Model 114 Service Letter Index (Cont)

SERVICE LETTER NO. SL-114-1A

CABIN NOISE REDUCTION

Figure 1.

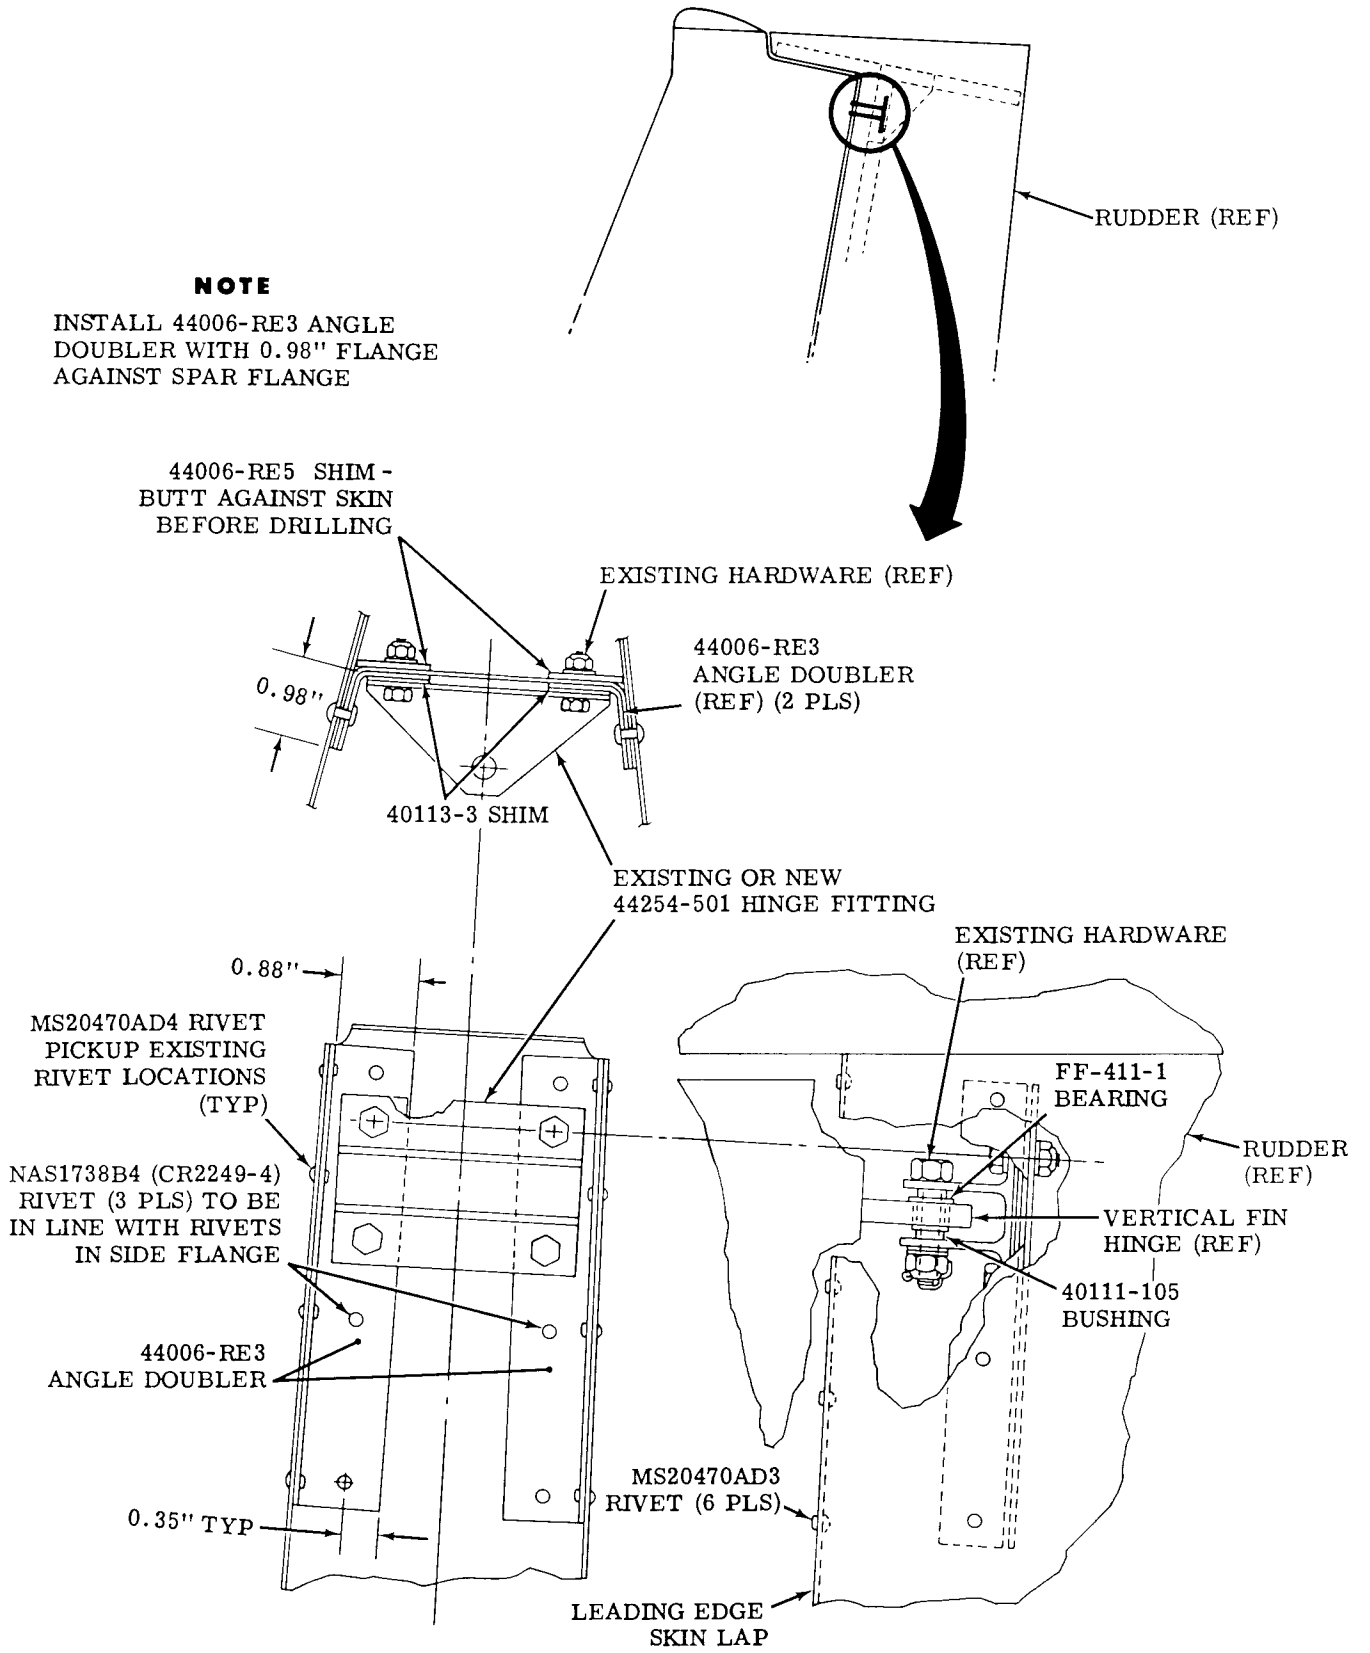
- b. Remove upper six (6) rivets from rudder assembly leading edge skin lap.
 - c. Stop drill all cracks with a No.40 (0.098) diameter drill.
 - d. Locate, drill and install 44006-RE3 angle doubler (2 places) on rudder assembly (see Figure 1.).

- e. If existing hinge fitting is to be used, trim 0.06-inch to 0.07-inch from each end of existing hinge fitting.
 - f. Install existing or new 44254-501 hinge fitting, 44006-RE5 shim (2 places) and 40113-3 shim (2 places) using existing hardware (see Figure 1.).

10. Reinstall tip on rudder assembly.
11. Remove and discard existing oilite bearing from upper vertical fin hinge.
12. Install FF-411-1 bearing in upper vertical fin hinge and ream hole in new bearing to 0.317/0.318-inch (see Figure 1.).

Figure 2.

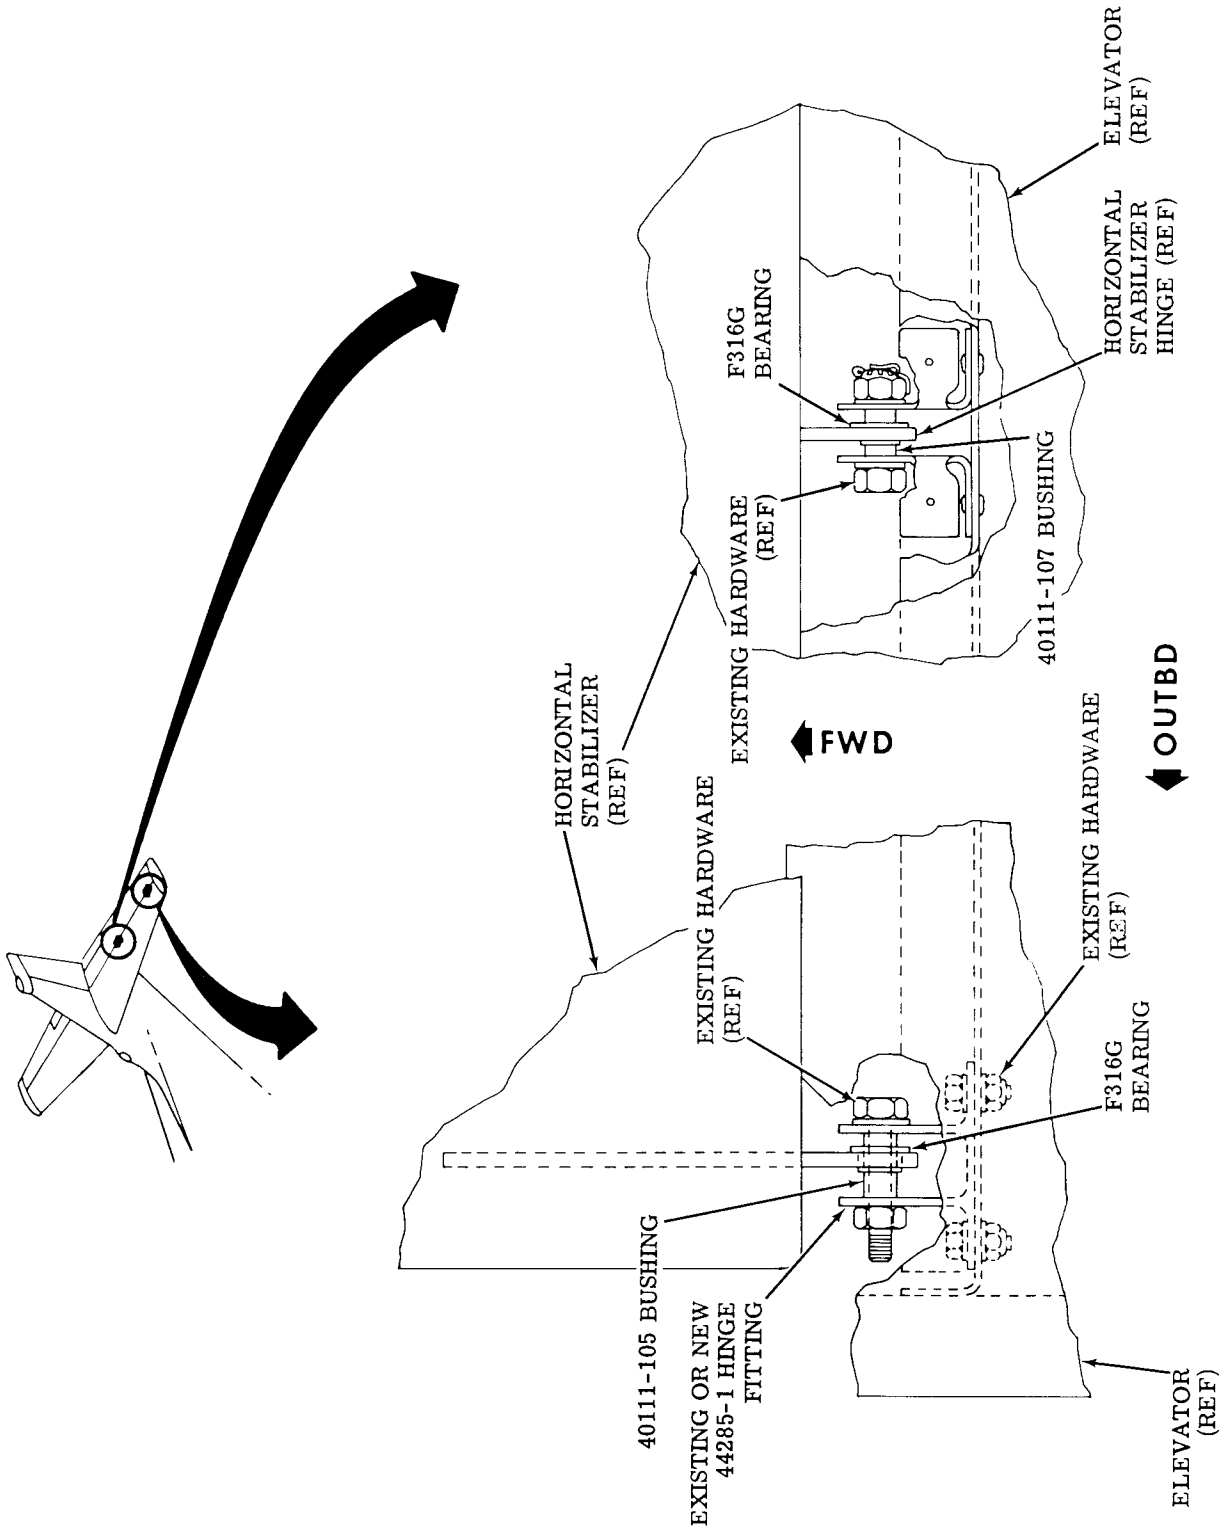
- d. Install new 44285-1 hinge fitting on elevator using existing hardware (see Figure 2.).
 - e. Attach skin to elevator structure using MS20426AD4 rivets and NAS1738B4 blind rivets.
 - f. Repaint elevator surfaces as necessary.
 - g. Reinstall tip on elevator.
18. Remove and discard existing oilite bearings from horizontal stabilizer center and outboard hinges.
 19. Install F316G bearing (4 places) on horizontal stabilizer center and outboard hinges and ream hole in bearings to 0.317/0.318-inch (see Figure 2.).
 20. Reinstall rudder assembly on airplane as outlined in the Airplane Maintenance Manual, Section VII, using existing hardware and 40111-105 bushing (see Figure 1.).

21. Reinstall left and right elevator assemblies on airplane as outlined in the Airplane Maintenance Manual, Section VII, using existing hardware, 40111-107 bushing (center hinge) and 40111-105 bushing (outboard hinge) (see Figure 2.).

Figure 1

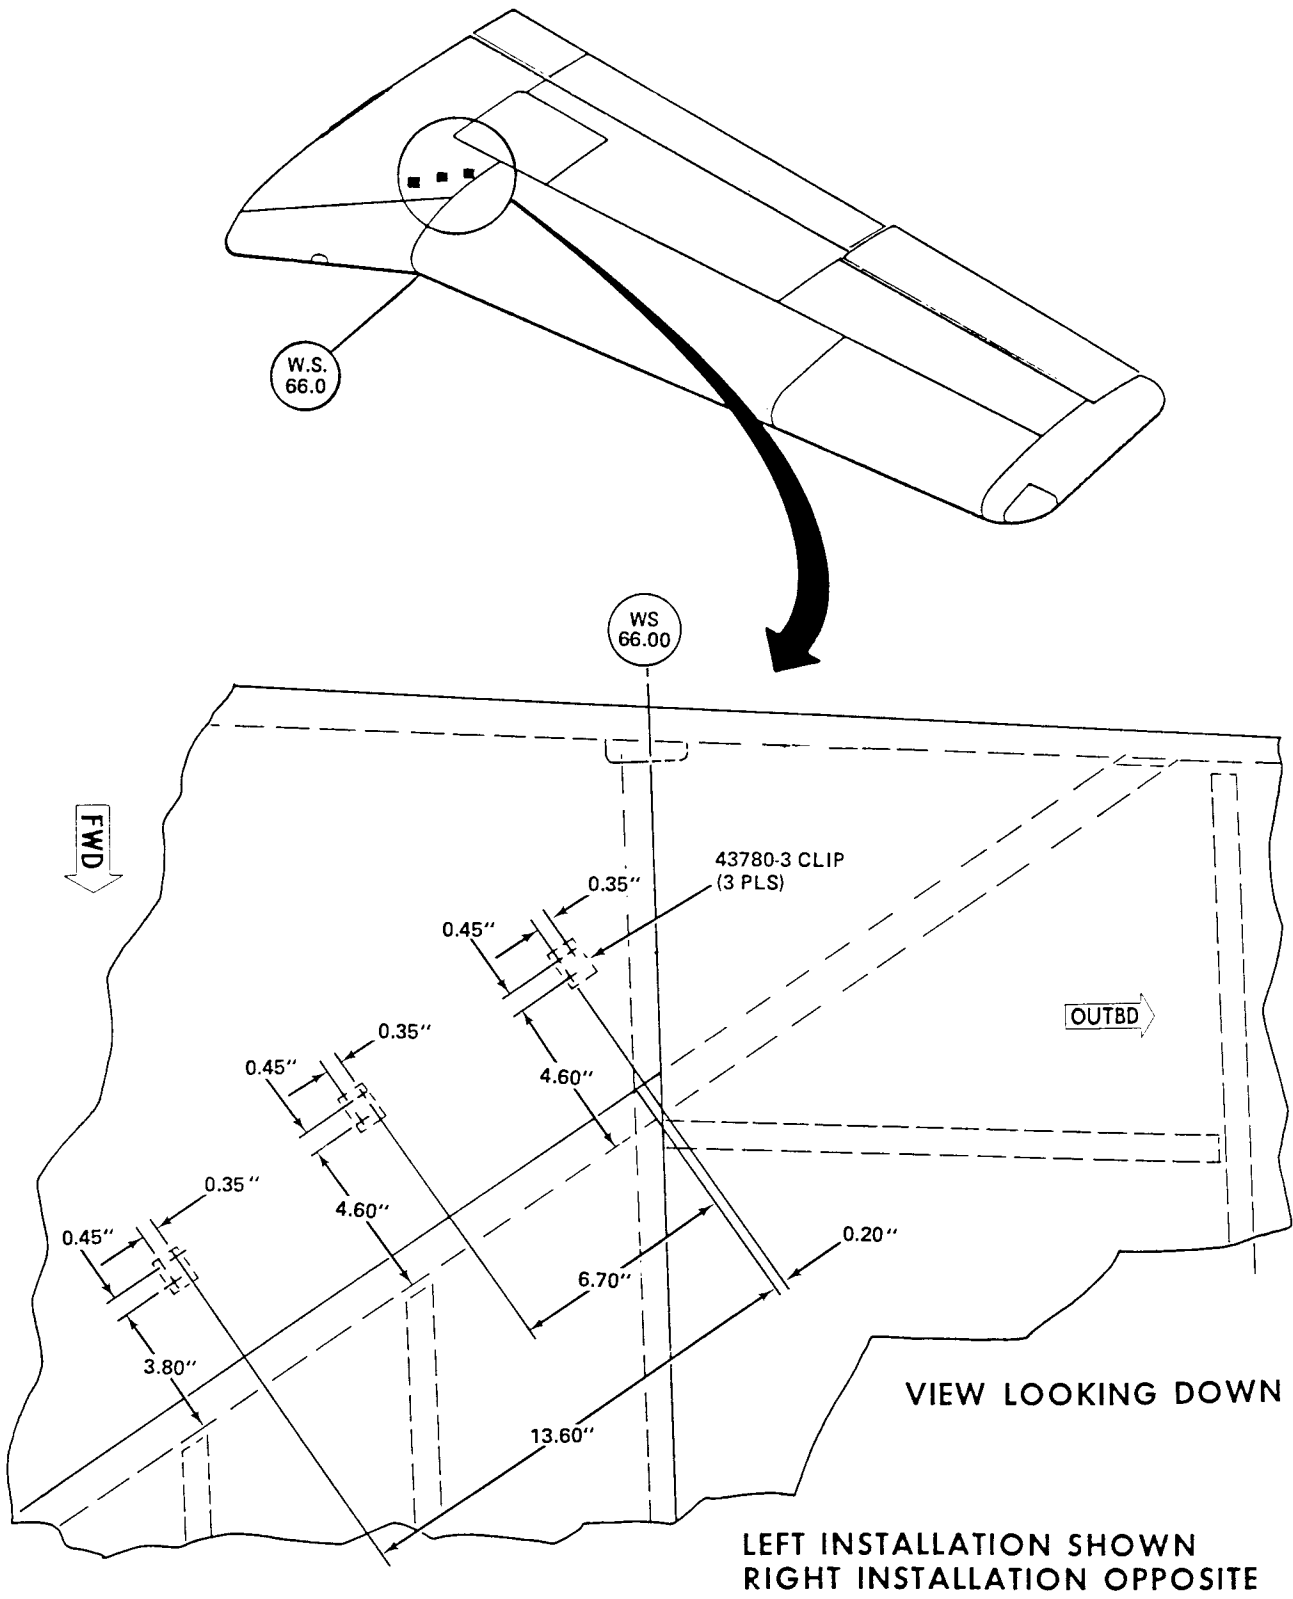
4. Locate, drill and install 43780-3 clip (3 places) on lower side of wing skin in left wheel well using MS20426AD3 rivets. Rivet heads are to be on top of wing skin (refer to Figure 1).

5. Locate, drill and install 43780-4 clip (3 places) on lower side of wing skin in right wheel well using MS20426AD3 rivets. Rivet heads are to be on top of wing skin (refer to Figure 1).

Figure 2. (Sheet 1 of 2)

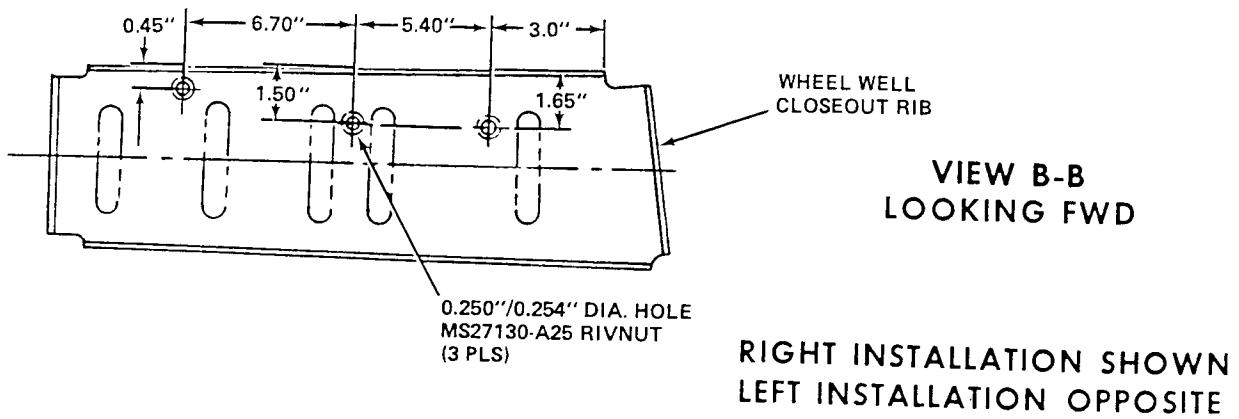
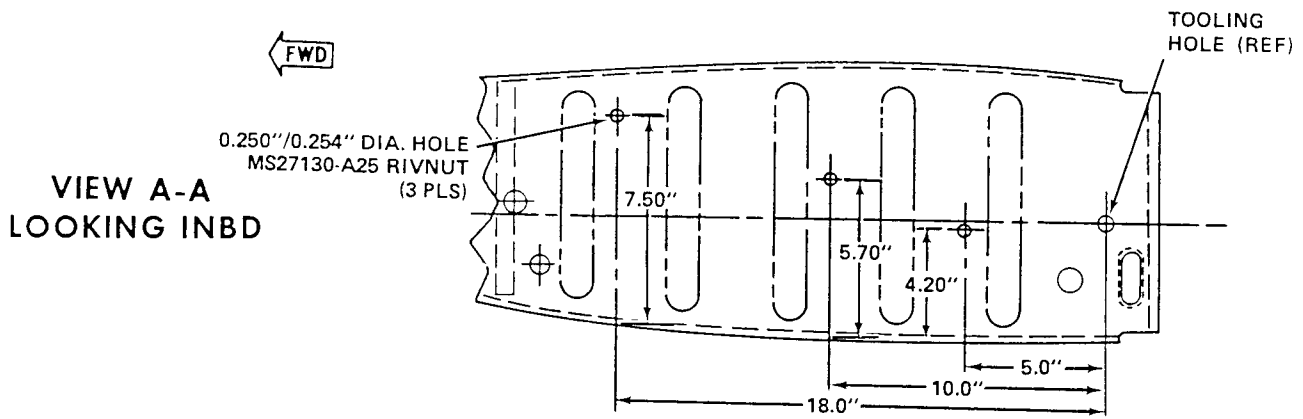
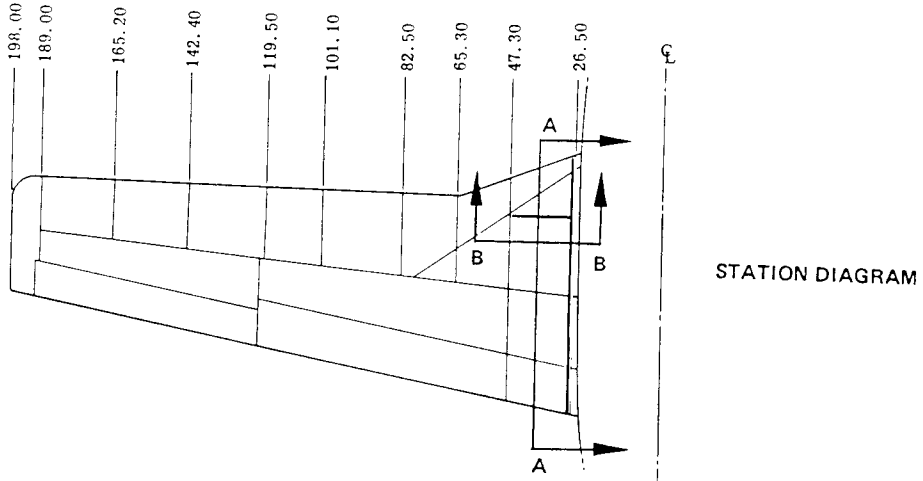
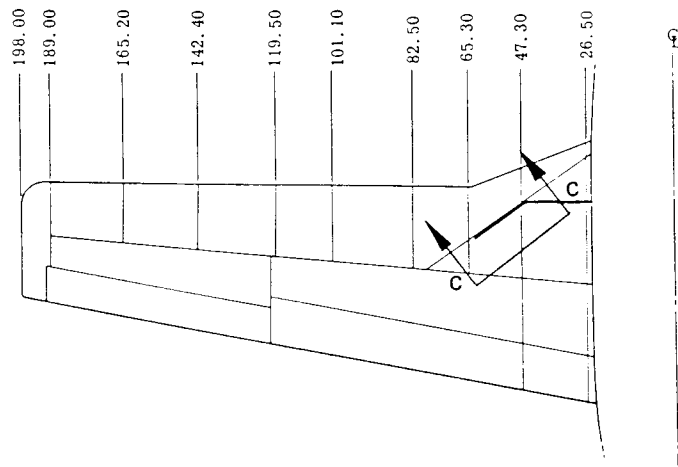
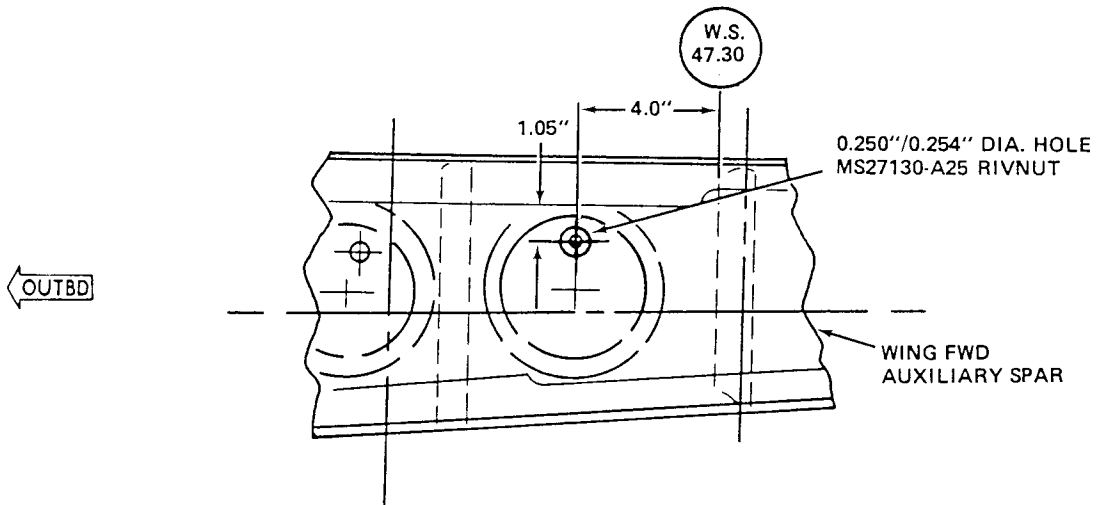
6. Locate and drill 0.252 (± 0.002) inch diameter hole (7 places) in left and right wheel well area for installation of MS27130-A25 rivnuts (refer to Figure 2).

7. Deburr all holes, prime area around holes with zinc chromate primer and install MS27130-A25 rivnuts (refer to Figure 2).
8. Locate and drill a 0.159-inch (No. 21) diameter hole, 0.63-inch deep, in right main landing gear trunnion. Tap 10-32 UNF-2B threads in hole by 0.50-inch deep (refer to Figure 3).

Figure 1

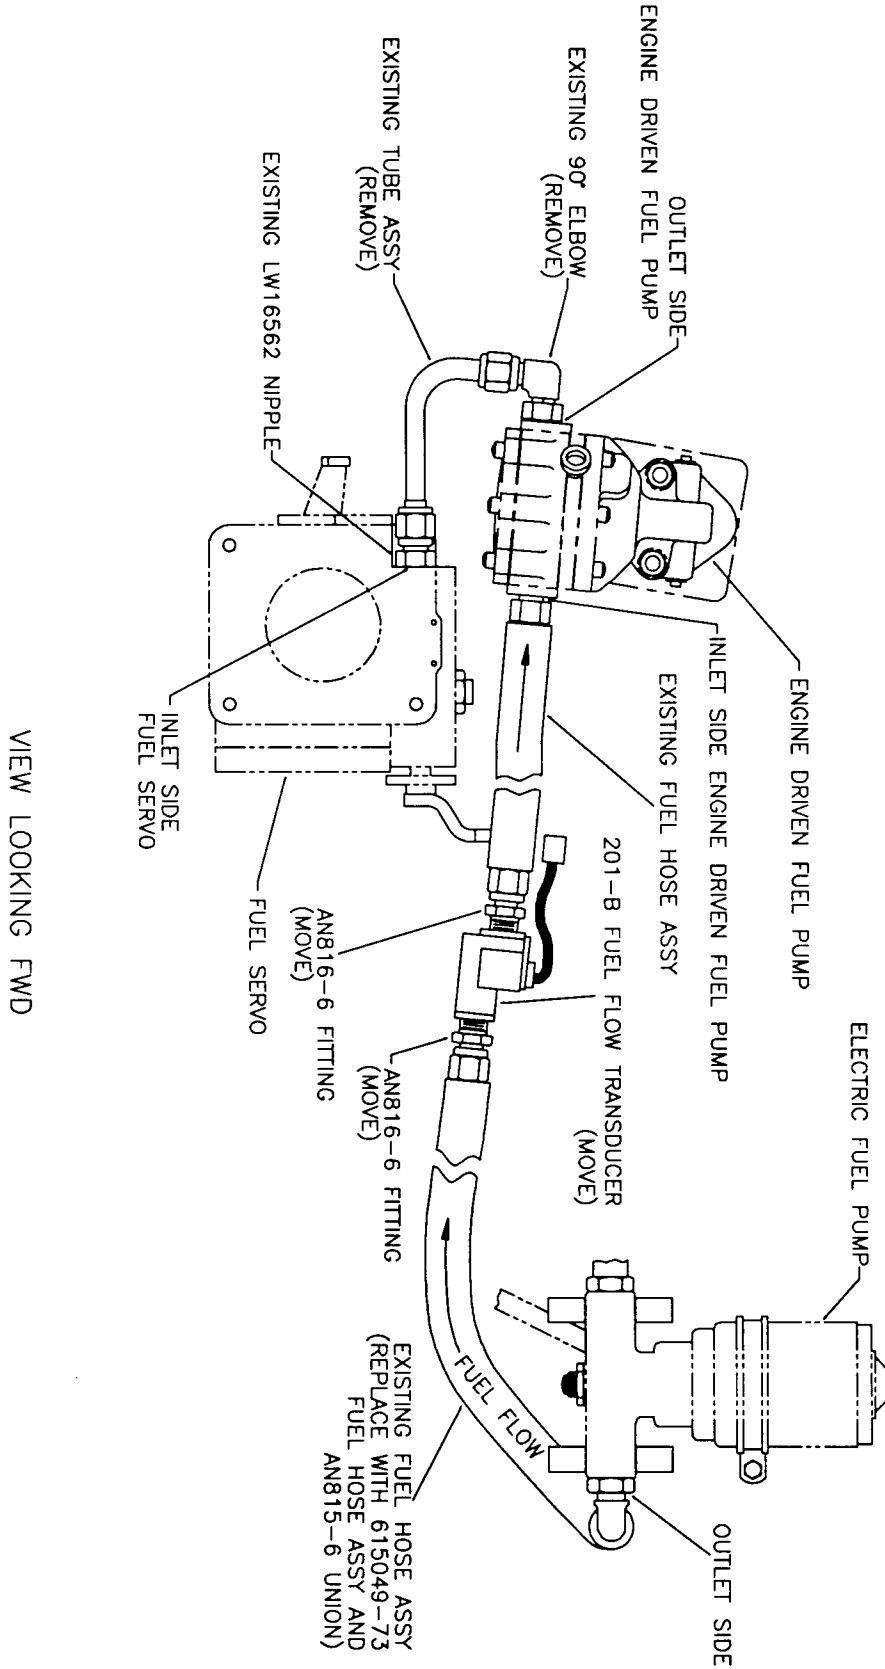
4. Disconnect the existing Fuel Hose Assembly from the outlet side of the **Electric** Fuel Pump (See Figure 1).
5. Attach one end of the 615049-73 Fuel Hose Assembly to the outlet side of the **Electric** Fuel Pump. Use the supplied AN815-6 Union to join the other end of the 615049-73 Fuel Hose Assembly and the free end of the existing hose assembly that is attached to the inlet side of the **Engine Driven** Fuel Pump. Torque all fittings between 100 in.lbs and 200 in.lbs.
